Heritage Officer Archaeology, Palaeontology and Meteorites (APM) Unit South African Heritage Resources Agency (SAHRA) Case ID: 19147 Arcus Reference: 4675 DA2S WEF Associated Infrastructure

RE: SAHRA INTERIM COMMENT on the PROPOSED DEVELOPMENT OF NEW TRANSMISSION LINES, A SWITCHING STATION, AND ACCESS ROAD FOR THE AUTHORISED DE AAR 2 SOUTH WEF, NORTHERN CAPE PROVINCE

Plate 1: Proposed Access Road overlain by the paleo sensitivity. Light blue marker highlights a section of the proposed access road (pink line) which crosses an area of palaeontological sensitivity (approximately 4 km).

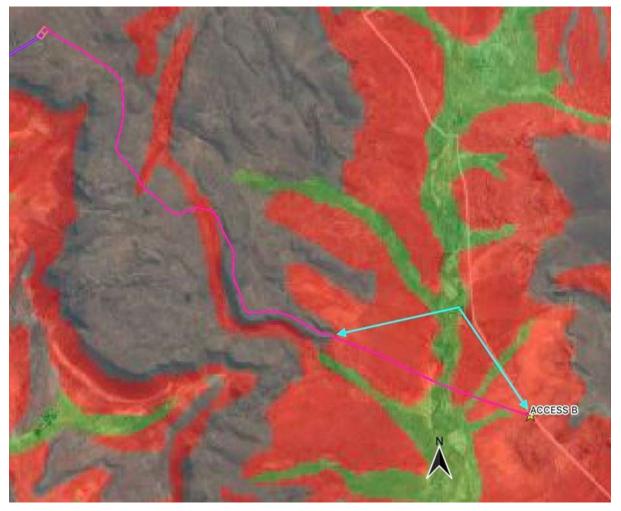
Given that the previous PIA for the Grid Connection route has been accepted by SAHRA we have assumed that the field survey requested in the recent interim comment requires the palaeontologist to assess the proposed access road. The bulk of this road is routed over non-fossiliferous dolerite but a section of \sim 4 km (refer to Plate 1 of Appendix 1) crosses an area of palaeontological sensitivity.

Given the proven paucity of fossil material in those areas of the landscape around De Aar which are covered in the Quaternary sands, we ask SAHRA to consider that no palaeontological field assessment of the access road is required at this stage or the process. Instead, the final Basic Assessment (BA) Report and Environmental Management Programme (EMPr) will include a recommendation for a site survey to be conducted prior to construction and / or once the final design of the access road has been determined – as included for the archaeological resources.
